# Historic Preservation Board Staff Report

**Author:** Anya Grahn, Historic Preservation Planner  
**Subject:** Material Deconstruction Review  
**Address:** 911 Empire Avenue  
**Project Number:** PL-17-03441  
**Date:** May 3, 2017  
**Type of Item:** Administrative – Material Deconstruction and Reconstruction

**Address:** 911 Empire Avenue  
**Designation:** Landmark  
**Applicant:** Tom Peek, represented by architect Jonathan Degray  
**Proposal:** Material Deconstruction of post-1983 railroad tie retaining wall, contemporary concrete block retaining wall, non-historic fence; demolition of post-1941 rear additions; non-historic porch railings on the front porch and post-1941 enclosed porch on the southwest corner; two (2) original front doors on the east and north facades and one (1) post-1941 door on enclosed porch; removal of 9’x9’ section of lower level façade wall to construct an invisible garage door; thirteen (13) historic wood windows; non-historic asphalt shingle roofing; brick chimney.

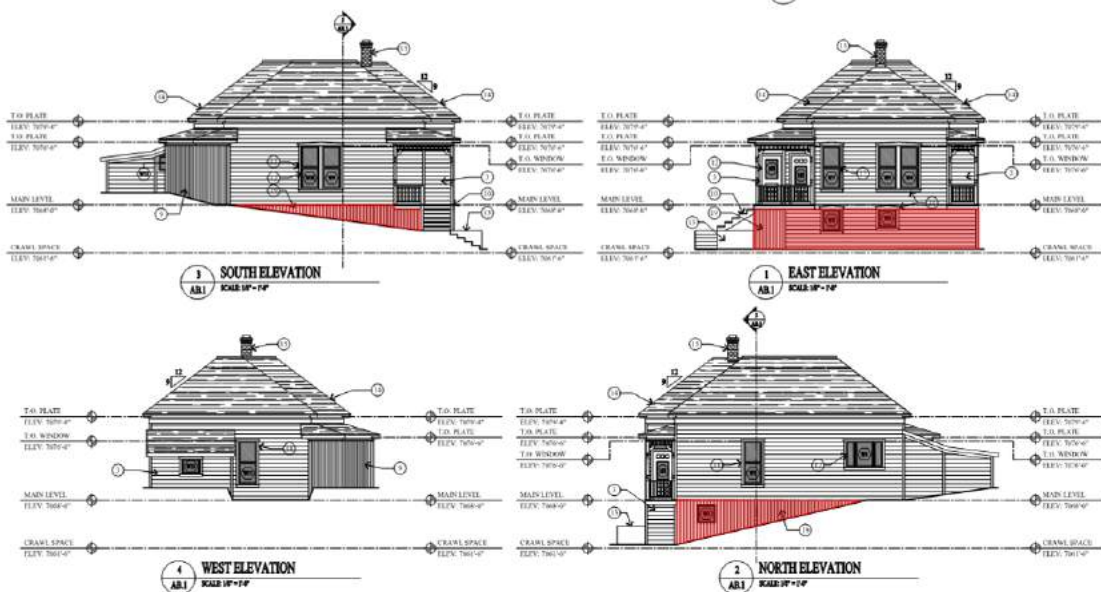
Staff has identified the fence and retaining walls in red below:

The applicant is proposing to remove these non-historic improvements. The front yard will be regraded and revegetated as a lawn. In the backyard, the applicant will be regrading and terracing the backyard with new stacked stone retaining walls, concrete planters, and vegetation in order to create an outdoor living space.

Staff finds that these improvements do not contribute to the historic integrity or historical significance of the site. The proposed exterior changes will not damage or destroy the exterior architectural features of the subject property that are compatible with the character of the historic site. Additionally, the majority of the proposed work is located in the rear yard and will not impact the visual character of the neighborhood.

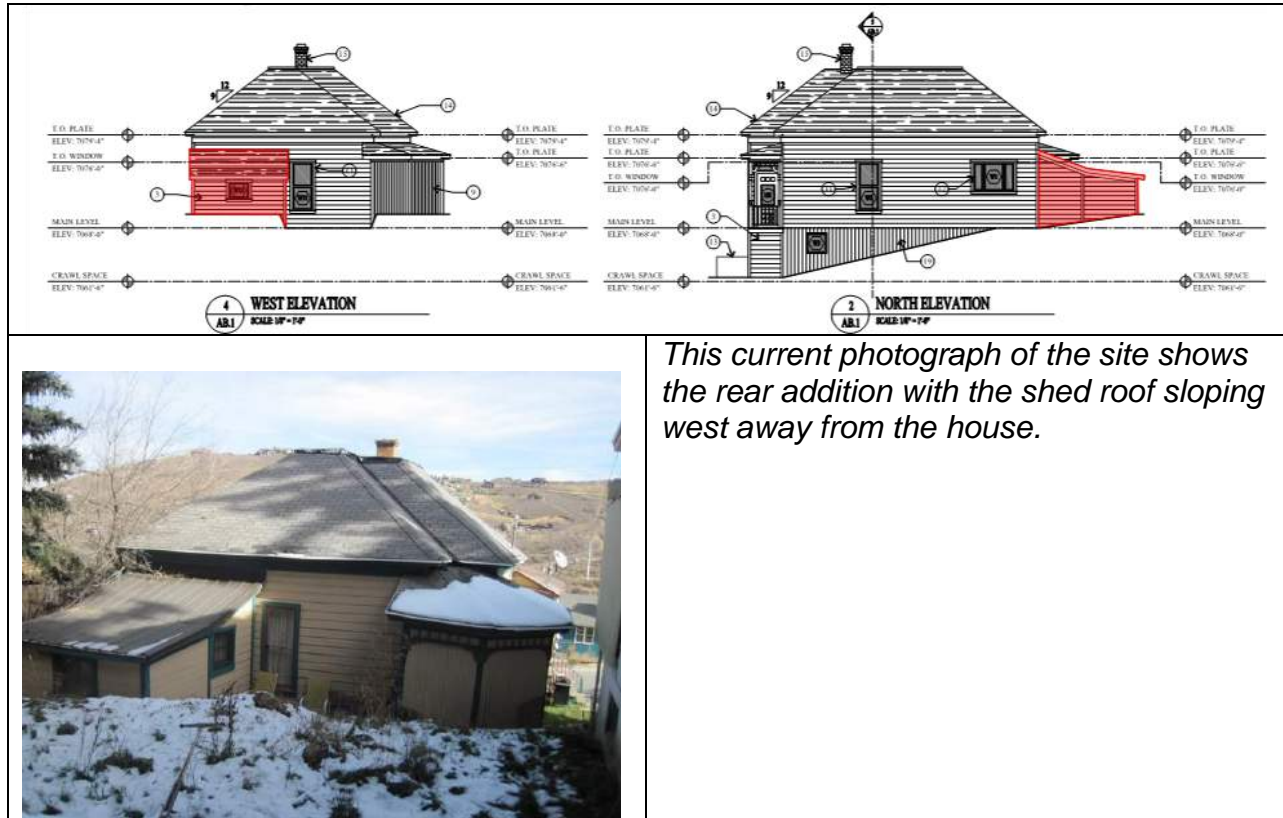
The exterior walls of the house consist of single-wall construction. The 1x12 horizontal and vertical wood planks of the interior are sided with 1x8 horizontal wood lap siding on the exterior. The applicant is proposing to remove all the contemporary materials from the interior of the house to determine the amount of surviving historic materials. The applicant proposes to rebuild the structure from the interior in order to meet the structural requirements of the International Building Code (IBC).

Staff finds that the proposed scope of work and any associated material deconstruction is necessary for the rehabilitation of the historic house. Staff anticipates that some siding on the house may be severely deteriorated and beyond repair. Staff has added the following Condition of Approval to address this:

*#3. Where the historic exterior materials cannot be repaired, they will be replaced with materials that match the original in all respects: scale, dimension, texture, profile, material and finish. Prior to removal, the applicant shall demonstrate to the Planning Director that the materials are no longer safe and/or serviceable and cannot be repaired to a safe and/or serviceable condition. The Planning Director shall approve the replacement in writing. This incorporates all elements, including, but not limited to, original trim, overhangs and eaves, etc.*

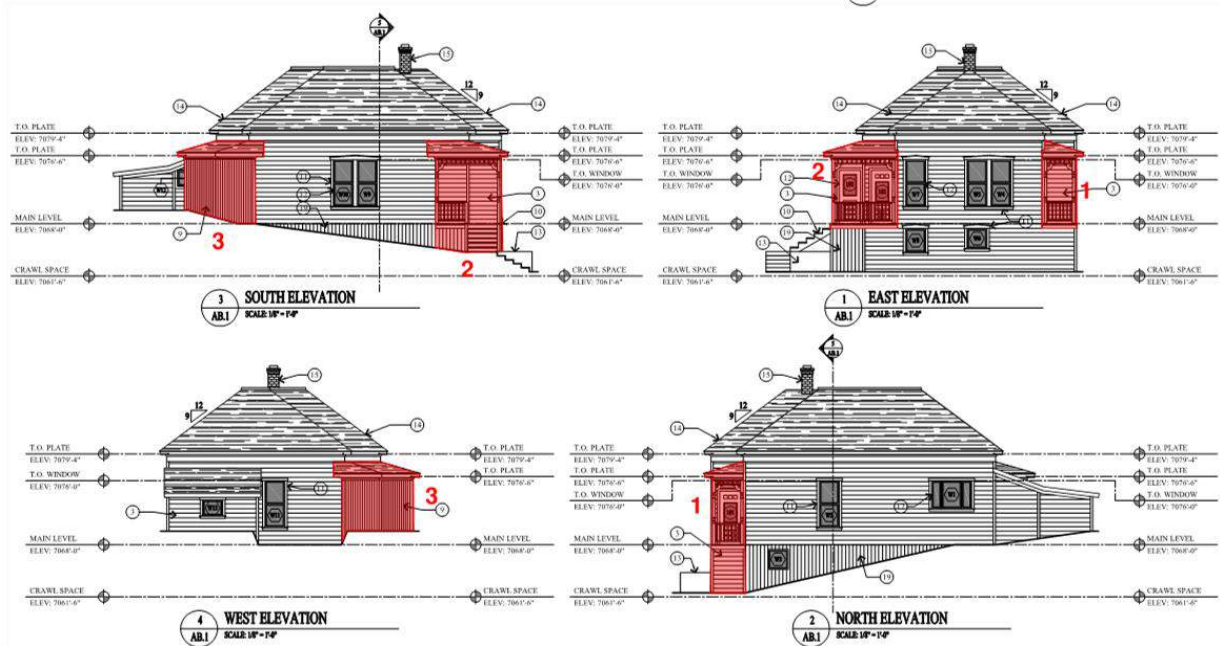
Staff has shaded these three porches in red below:

The applicant believes that Porches 1 and 2 can be lifted with the house to pour the foundation. The applicant believes the historic materials will be able to be preserved. Contemporary additions to the porches, such as the wood railing, will be replaced with new materials. Staff finds that the material deconstruction is required for the restoration of the building.

The applicant believes that Porch 3 on the southwest corner of the house will need to be demolished and reconstructed to facilitate the lift. They anticipate trying to salvage any historic materials they find on this porch to reuse in the reconstruction following construction of the foundation. Staff finds that the material deconstruction is required for the reconstruction of Porch 3 as an open porch.

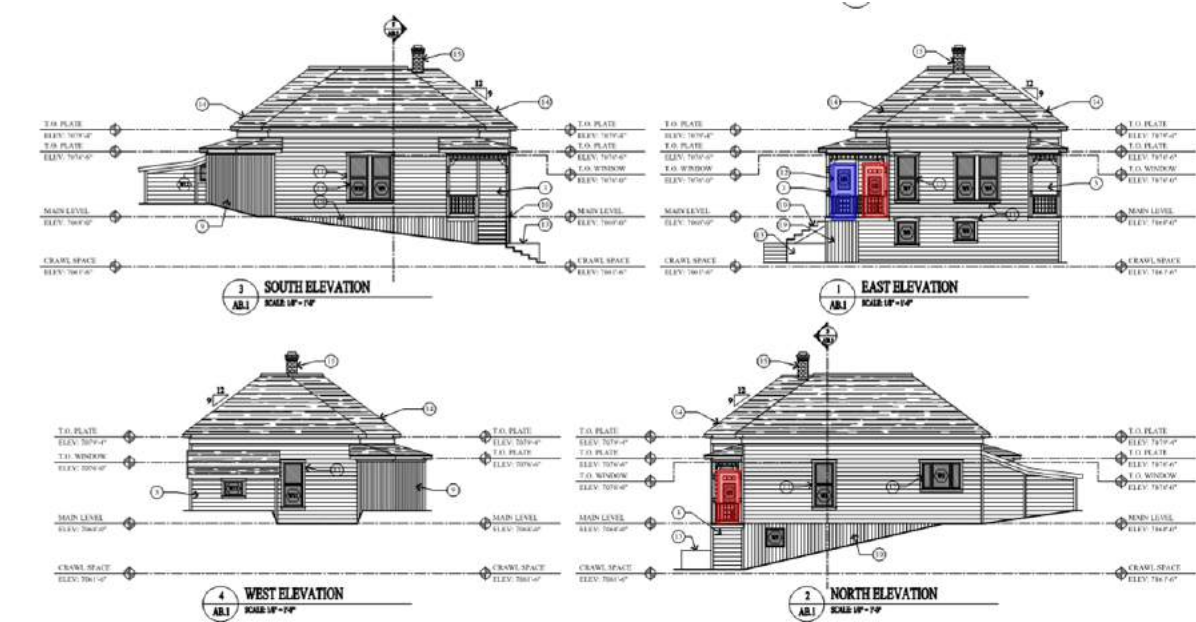
There are three (3) historic doors on the exterior of the historic house. The applicant's physical conditions report finds that these doors are in fair condition. The doors on the front of the house may be restored or may require replacement. The door on the enclosed porch will be removed as part of the restoration of the original open porch design.

The applicant is proposing to review with staff the condition of the two (2) historic doors on the front of the house. Staff has added Condition of Approval #4 which states requires that the applicant shall coordinate with staff to determine if the two (2) historic doors on the front of the house can be restored or will require replacement. Should the doors need to be reconstructed due to their deteriorated state, they shall be replaced in-kind with new doors that match the original in all respects: scale, dimension, texture, profile, material, and finish. The replacement of the doors shall be approved by the Planning Director in writing prior to removal.

The two doors to be restored are shaded in red and the third door to be removed is shaded in blue below:

Staff finds that the material deconstruction on the two (2) historic front doors is required for the restoration of the house.

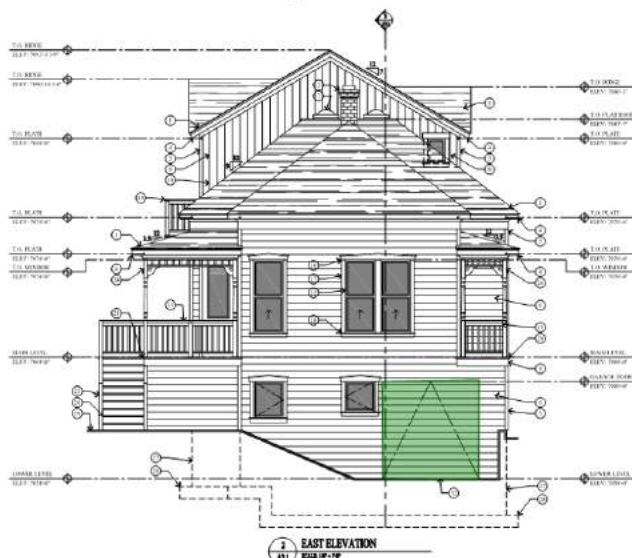
The applicant is also proposing to remove a section of the wall on the lower level of the façade in order to accommodate a new garage. Staff has shaded the location of the new garage door in green below:

The applicant is proposing to salvage the historic siding from this wall and install it over the new garage door so as to conceal its appearance. The photos below

Staff finds that the proposed material deconstruction mitigates any impacts that would occur to the architectural integrity of the building. The proposed exterior change would not damage or destroy the exterior architectural features of the subject property that are compatible with the character of the historic site and are not included in the proposed scope of work.

7. Windows

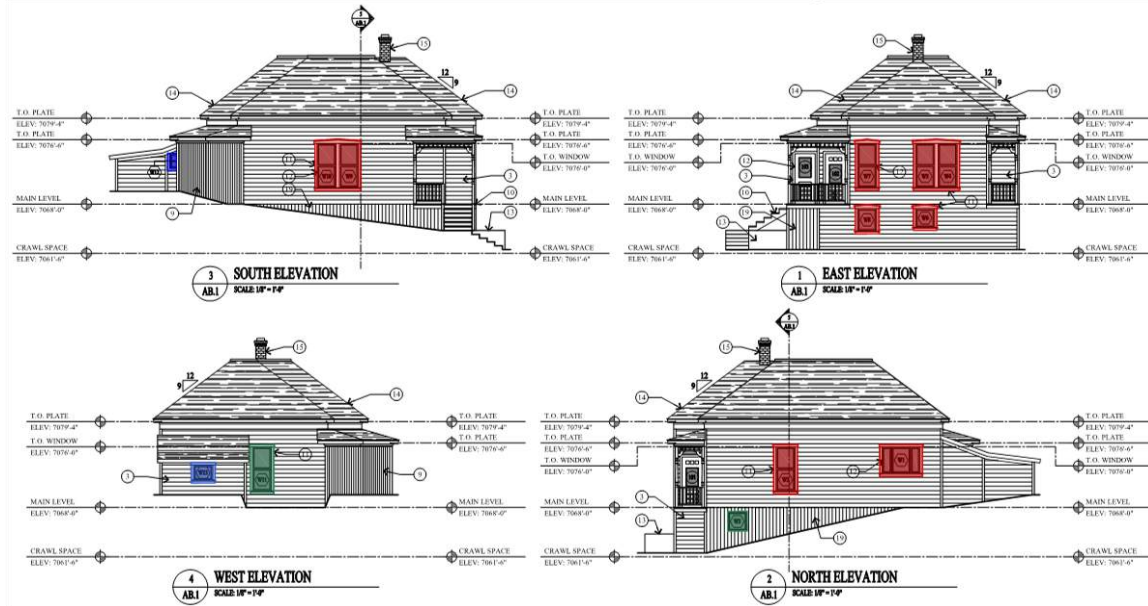
Staff has shaded the historic window openings in red, non-historic openings in blue, and openings to be altered in green:

The applicant is proposing to remove the historic windows (shaded red) and replace them with new wood windows. The applicant has had a window assessment completed by American Heritage Window Rebuilders (Exhibit E), and they found that the windows were beyond restoration. They need to be replaced in-kind.

The non-historic windows (shaded blue) are on the rear addition and are proposed to be removed along with the addition.

There are two (2) historic windows to be altered (shaded green). On the west (rear) elevation, the historic window opening will be covered by the new addition. On the north (side) elevation, the applicant is proposing to remove and cover this historic window opening. Staff finds that the lower level window opening is not a character-defining feature. As a basement-level window, it was likely always concealed by vegetation in the side yard.

Staff finds that the proposed material deconstruction is required for the restoration of the windows and renovation of the structure. By replacing the wood windows in-kind, the proposed scope of work mitigates any impacts that will occur to the historical significance of the building and the architectural integrity of the building. The proposed modifications to the remaining window openings will not impact the historical significance or architectural integrity of the building.

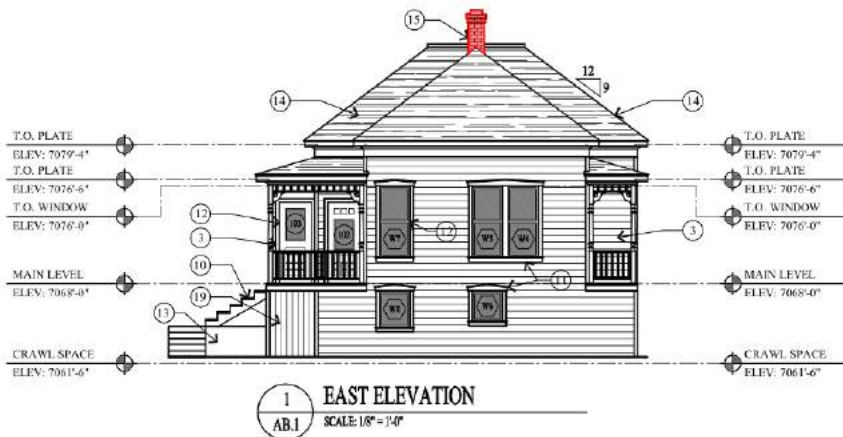
The asphalt shingles and flashing are in need of repair. The roof currently does not meet the code requirements for snow load. The applicant believes that the roof will likely need to be reconstructed in order to meet the structural requirements of the code and retain the historic form and appearance. Because no interior exploratory demolition has occurred, staff believes it may not be necessary to reconstruct the roof in its entirety. Staff has added the following Conditions of Approval to address this:

*#6. The applicant shall maintain the original pyramid variant roof form. Structural stabilization shall occur by adding new structural members to the interior of the roof.*

*#7. Should restructuring the roof from the interior not be possible due to the condition of the existing roof structure, the applicant shall schedule a site visit with the Chief Building Official and Planning Director to evaluate the condition of the roof structure. The applicant shall also submit a structural engineer's report to the Planning Director outlining the defects in the roof that prevent the new structure from being added alongside the existing roof members. The Physical Conditions Report and Preservation Plan shall be amended to document the condition of these walls and provide an updated scope of work to the satisfaction of the Planning Department. Any changes, modifications, or deviations from the approved scope of work shall be reviewed and approved by the Planning Director in writing prior to construction.*
